Beechcraft® SERVICE BULLETIN

No. 2165, Rev. II
ATA Code 76-10

SUBJECT: ENGINE CONTROLS - REPLACEMENT OF THE MIXTURE CONTROL CABLE ASSEMBLY

SYNOPSIS OF CHANGE: Corrected callout part numbers in Figure 1, Figure 3 and step 14 and updated Service Bulletin format.

B19 Sport 180 and C23 Sundowner 180
 Figure 2

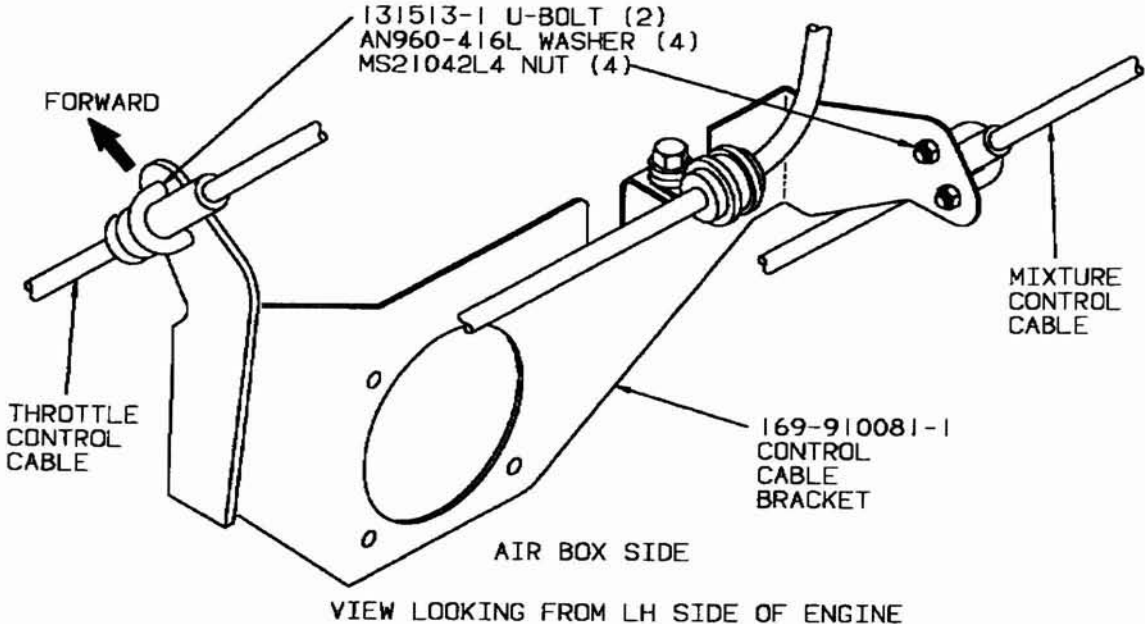
9. On B19 Sport 180 and C23 Sundowner 180 airplanes, remove the existing cable bracket and install a new P/N 169-910081-1 bracket as shown in Figure 2.
